Access Compliance Report

Public Rights-of-Way

(Curb Ramps)

Intersection ID: 44702	Main Street: PATRIOTS_POINT_LN	Cross Street: EAGLES_LANDING_DR	Location: NW
ADA ID: 442BCB2CE7E9	Ramp Type: PerpDiag	Initial Pass/Fail: Fail	Overall Compliance: No
Severity Score: 10			
Codes/Mitigation Info/Possible Solution		Field Measurements/Component Compliance

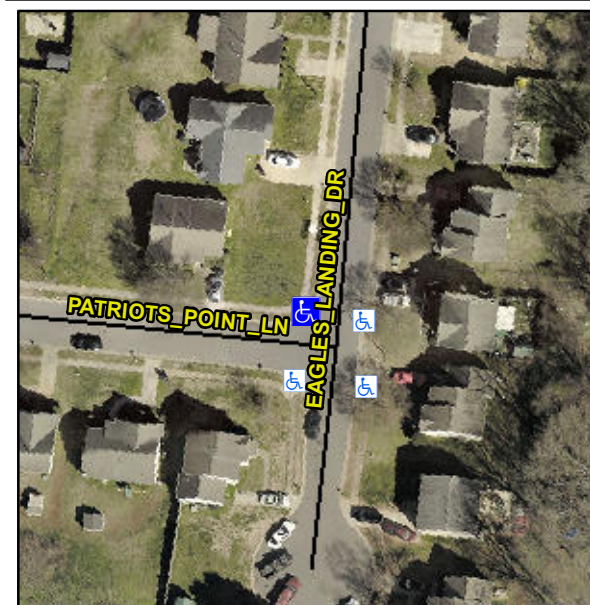
PROW/ADA:

R304.5.1, R304.5.3

Compliance	Description	Data	Compliance	Description	Data
N/A	Ramp Length (in)	48.0	Yes	Ramp Slope (%)	5.2
No	Ramp Width (in)	47.5	No	Ramp XSlope (%)	2.2
N/A	Flare Type LT	N/A	N/A	Flare Type RT	N/A
N/A	Flare Slope LT (%)	N/A	N/A	Flare Slope RT (%)	N/A
N/A	Flare Traversable LT?	N/A	N/A	Flare Traversable RT?	N/A
N/A	Landing Length (in)	N/A	N/A	DWS Provided?	N/A
N/A	Landing Width (in)	N/A	N/A	DWS Contrast?	N/A
N/A	Landing Slope (%)	N/A	N/A	DWS Length (in)	N/A
N/A	Landing X Slope (%)	N/A	N/A	DWS Full Width?	N/A
N/A	Landing Curb? (Y/N)	N/A	N/A	DWS Offset (in)	N/A
N/A	Shared Landing?	N/A			
N/A	Gutter Ponding?	N/A	N/A	Gutter Slope (%)	N/A
N/A	Gutter Lip Ht (in)	0.5	N/A	Gutter X Slope (%)	N/A
N/A	Painted X Walk1?	No	N/A	Painted X Walk2?	No
	X Walk 1 Direction	To S		X Walk 2 Direction	To E
N/A	X Walk 1 Width (in)	N/A	N/A	X Walk 2 Width (in)	N/A
	X Walk 1 Slope (%)	4.2		X Walk 2 Slope (%)	4.2
	X Walk 1 X Slope (%)	1.2		X Walk 2 X Slope (%)	0.3

N/A	Ramp inside XWalk1?	N/A	N/A	Ramp inside XWalk2?	N/A
	Road Slope (%)	3.8	N/A	Clear Space?	N/A
	Road X Slope (%)	4.7	N/A	Clear Space to XWalk (in)	N/A
N/A	Any Obstructions?	N/A	N/A	Storm Grate/Utility Hazard?	N/A
	Obstruction Type			Storm Grate/Utility Type	
		N/A			N/A
			Yes	Surface Condition? (G/P)	Good

Remove & Replace Curb Ramp With Two New Directional Ramps or Equivalent.
